San Juan Police Building Expansion

Addendum NO. 02

CSP No. 25-004-3-13

Date: 03/11/2025

AS102

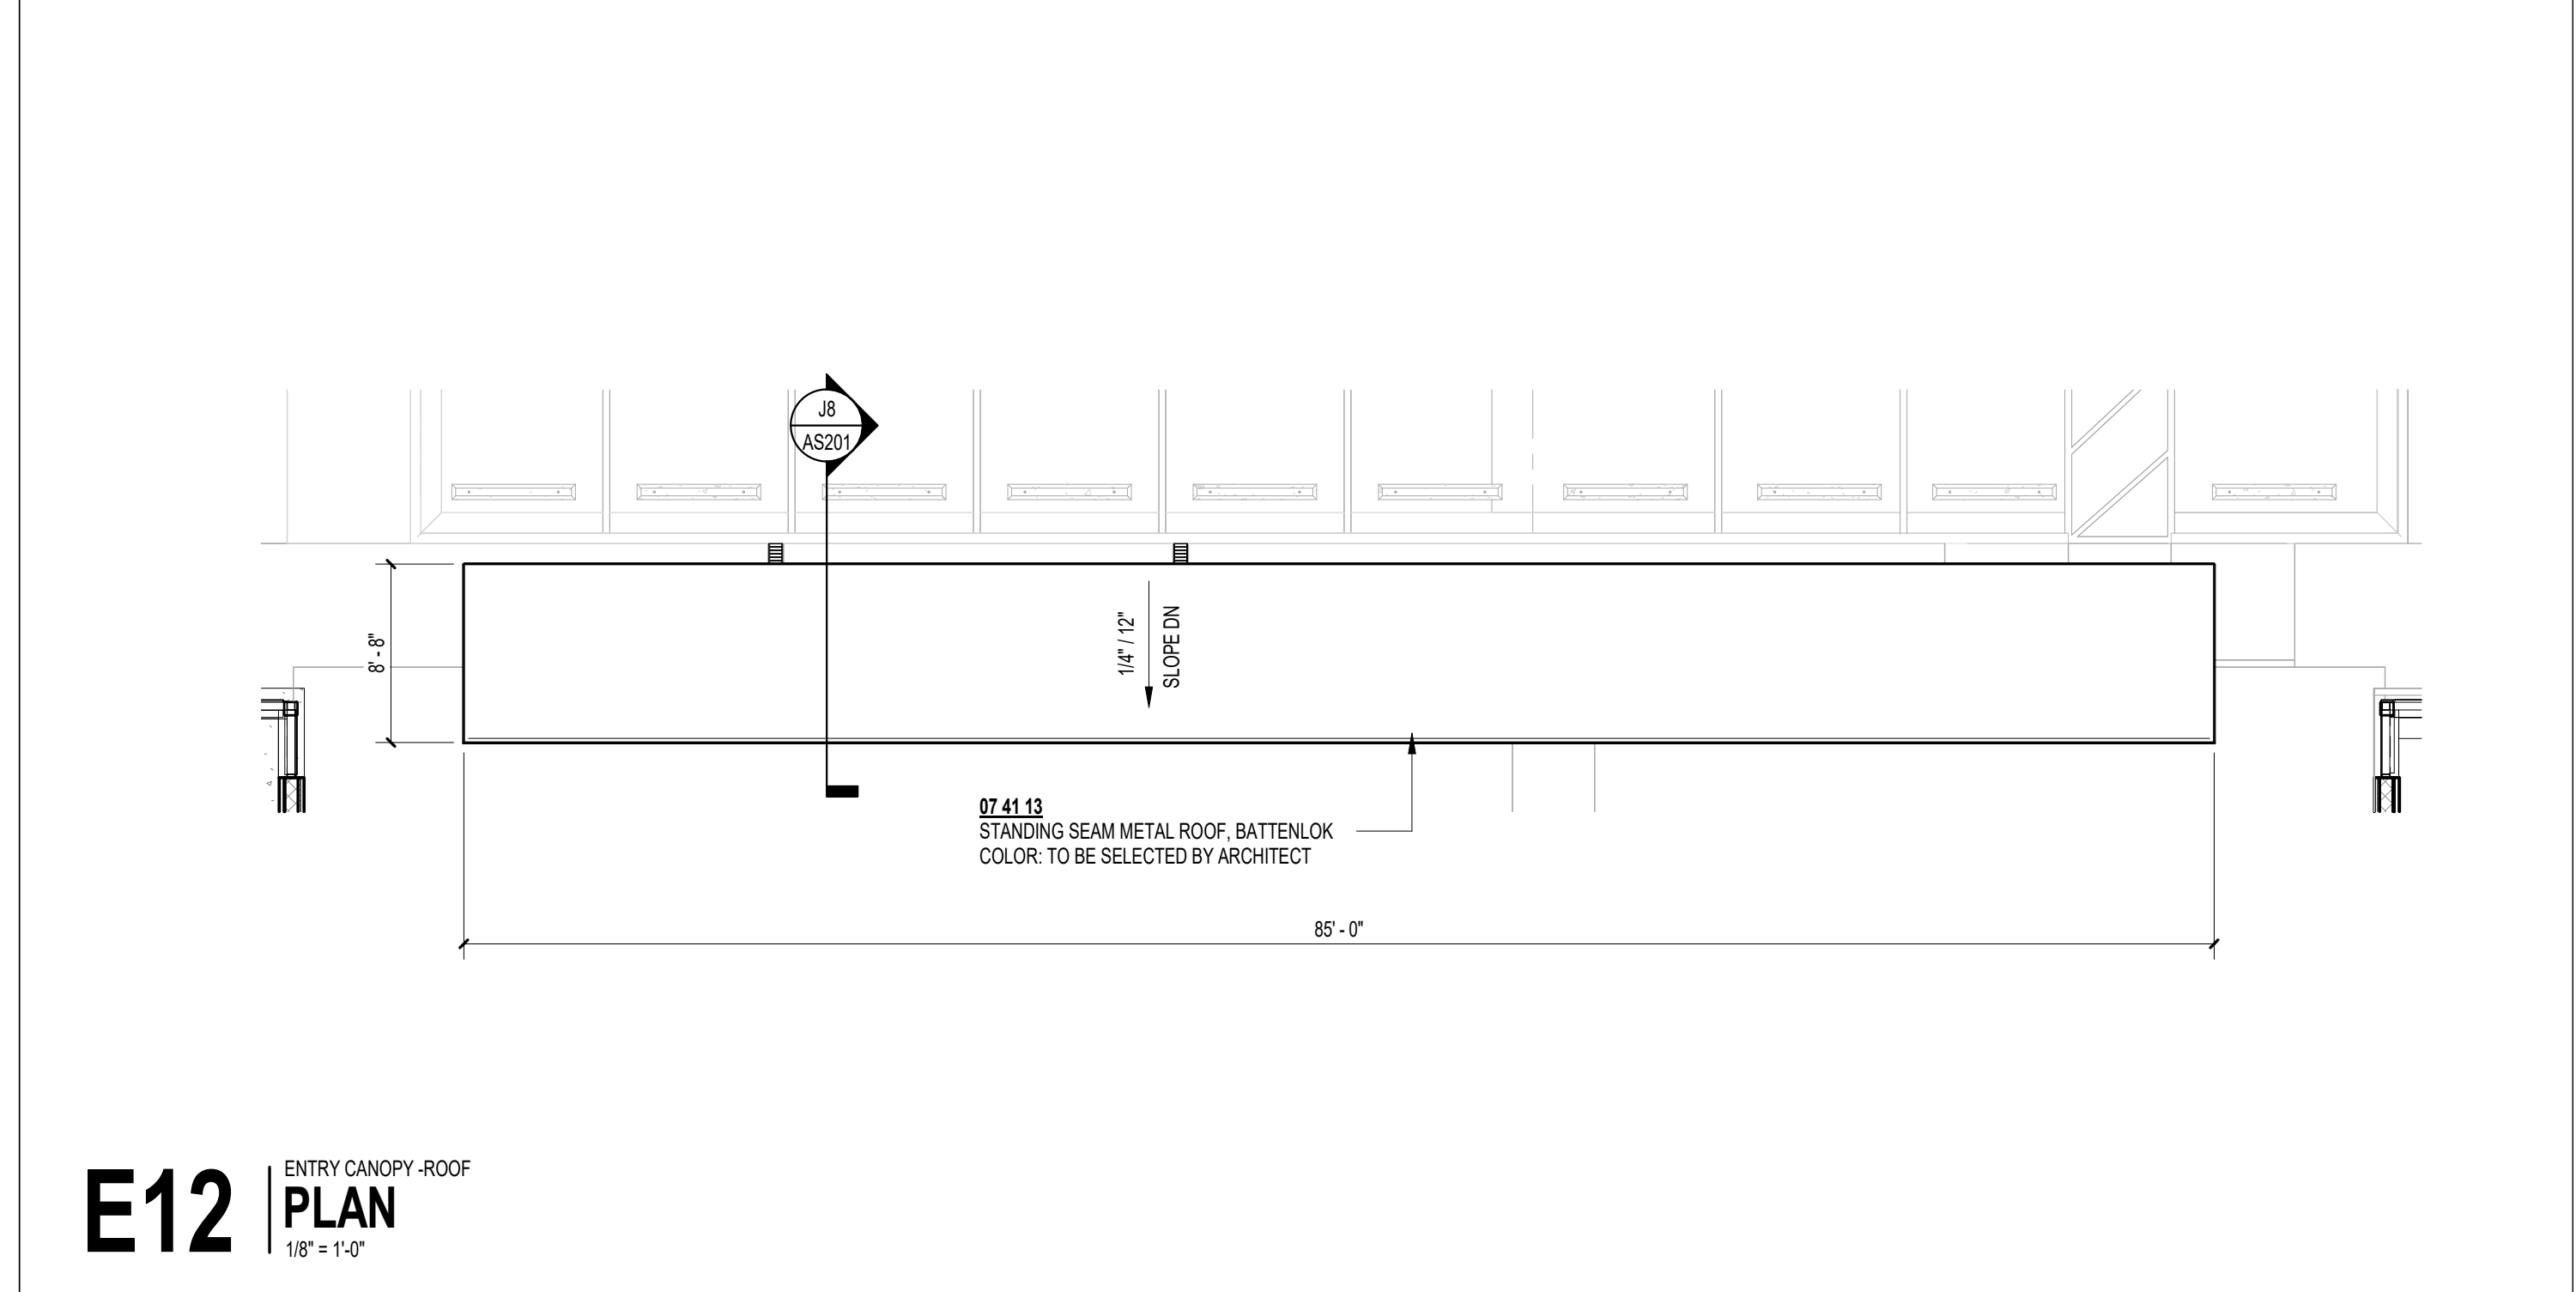
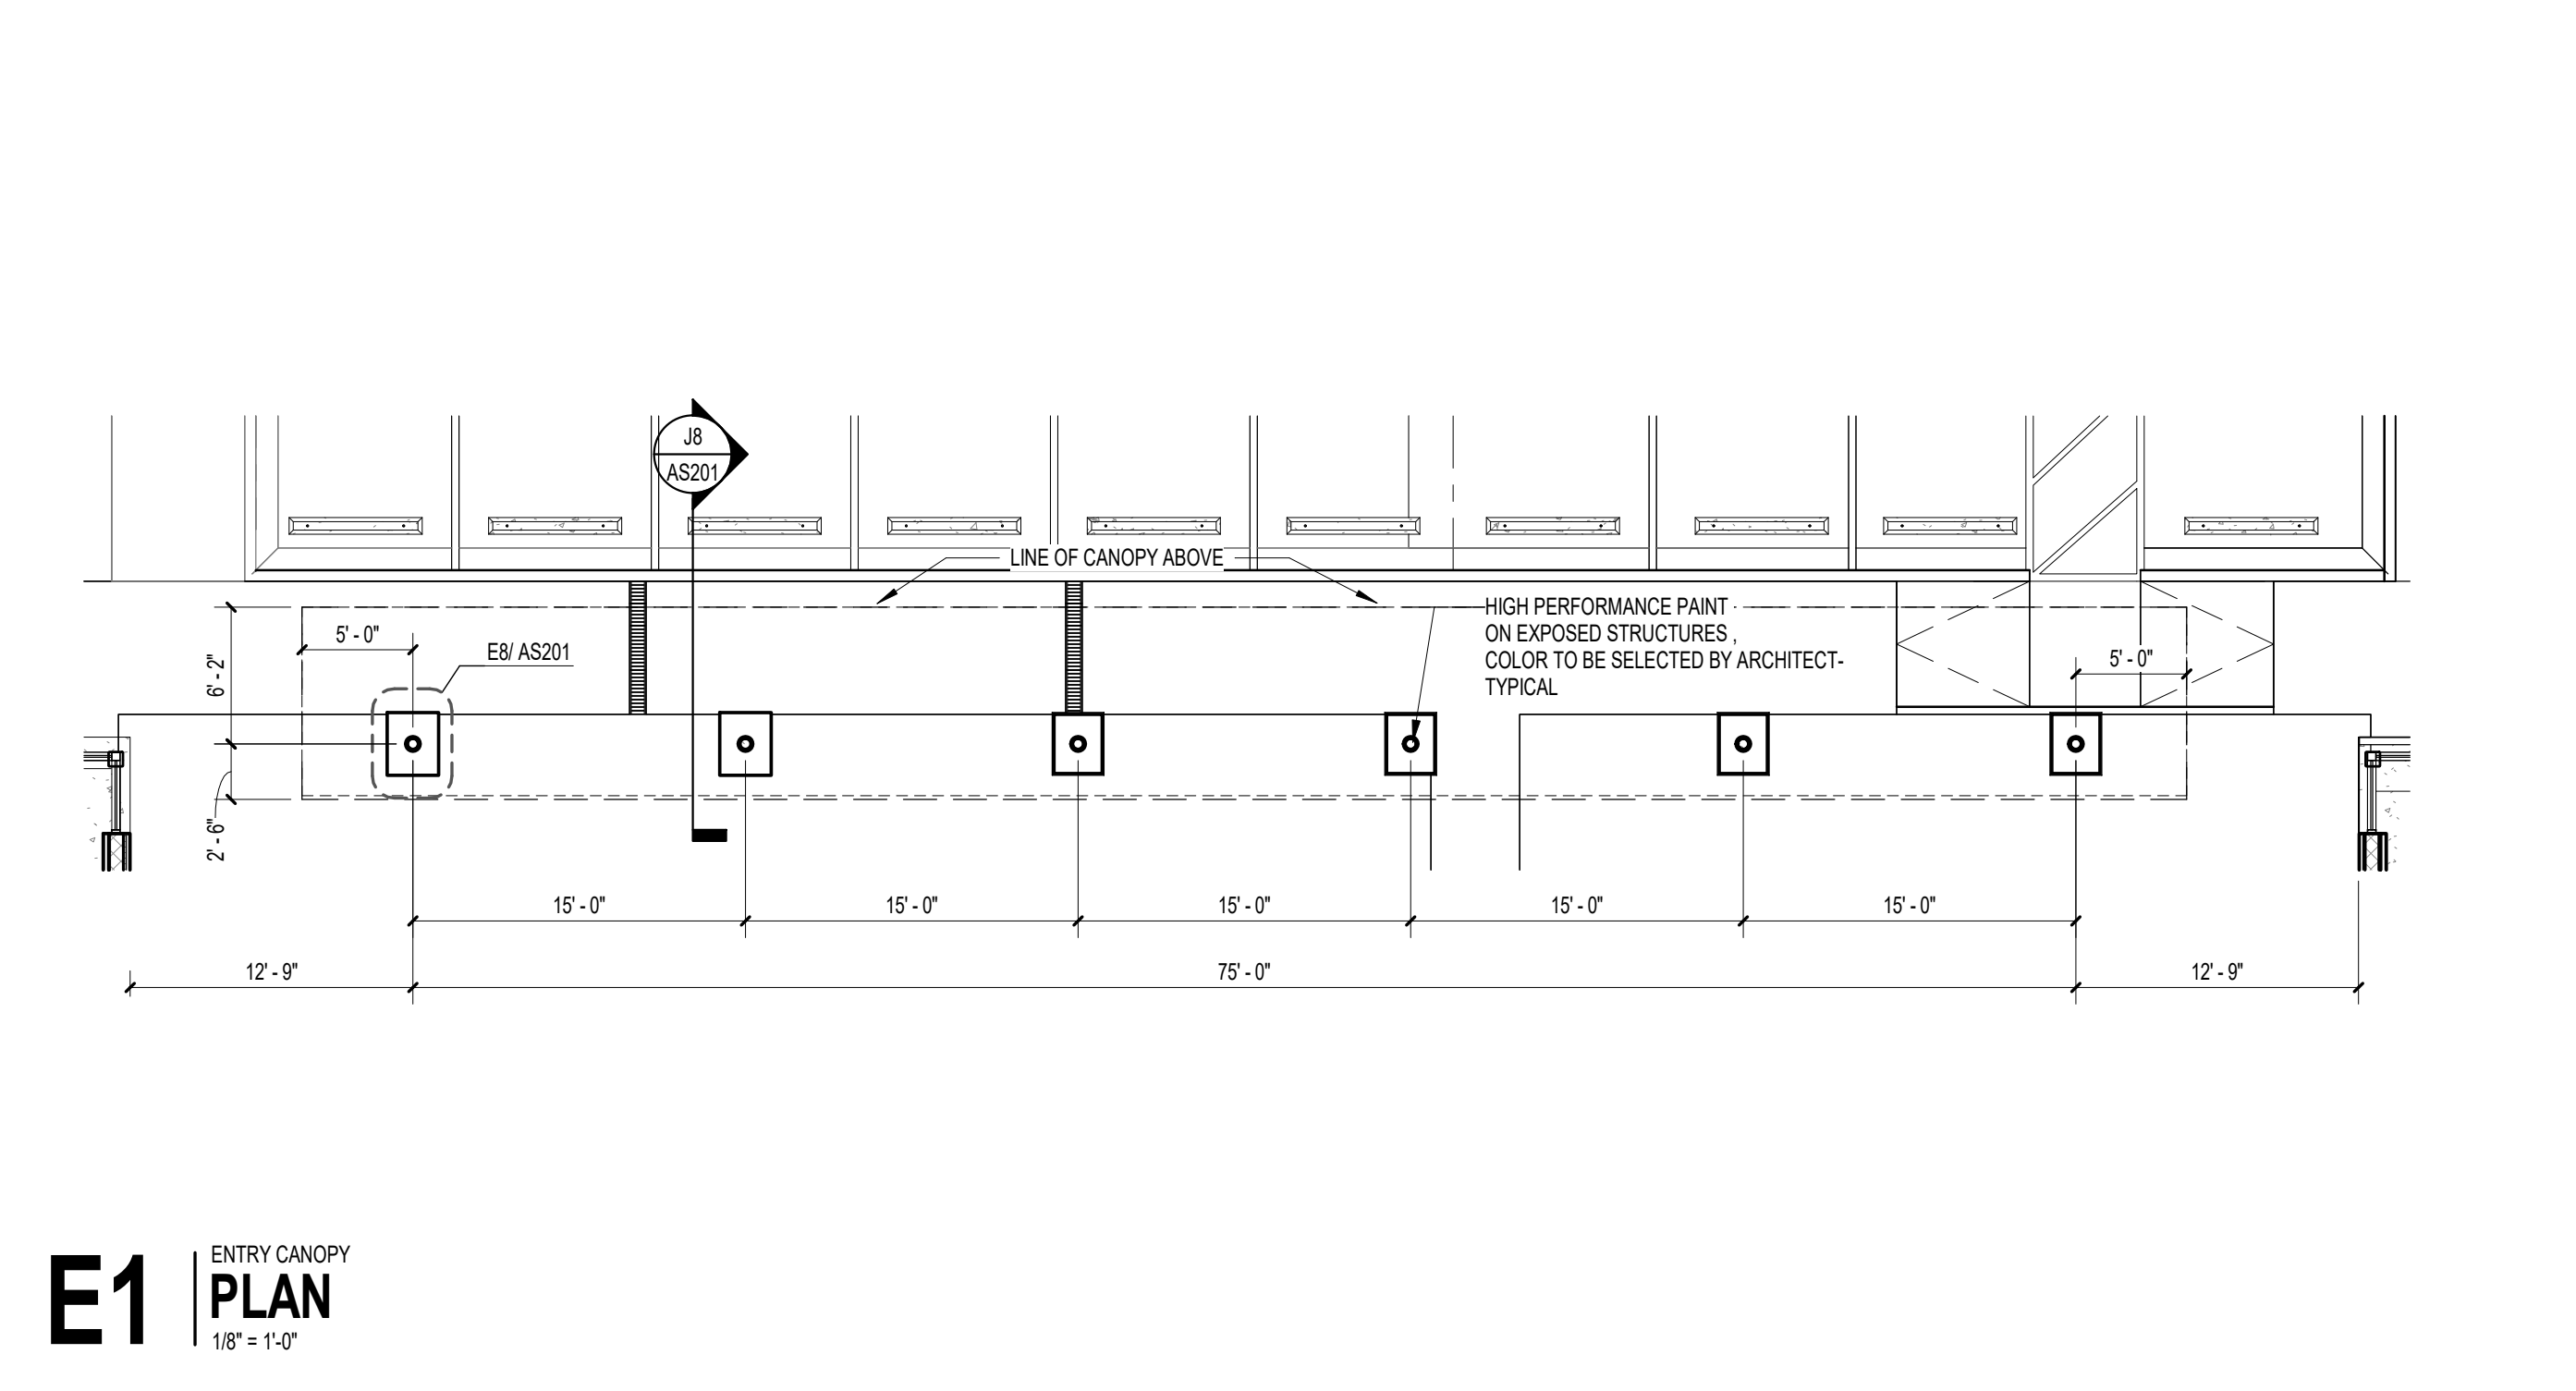
Sheet AS102 – ENLARGED SITE PLANS, Delete Sheet AS102 in its entirety.

Replace with revised SheetAS102 (refer to attached).
